# Bellevue Planning Commission

## Staff Responses to Commissioner questions from December 11, 2024 study session.

ACTIVE TRANSPORTATION ACCESS SECTION VIEW: CONDITION A

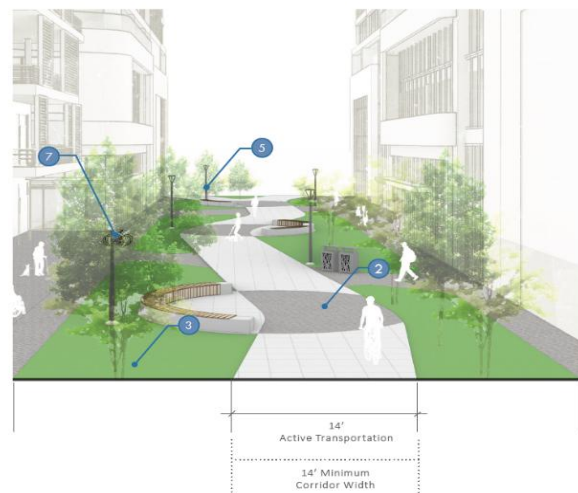
- The initial proposal required a 40-foot corridor width without the option to incorporate a fire lane. In the October draft, this width was reduced to 30 feet, with the added flexibility to incorporate a fire lane, provided its width is increased from 20 feet to 30 feet. The proposed 30-foot width is intended to accommodate elements such as furniture, lighting, landscaping, or other amenities. This corridor width allows for the inclusion of five feet on either side of the corridor—or alternatively, 10 feet on one side—for features that enhance comfort and create a more legible and inviting block.
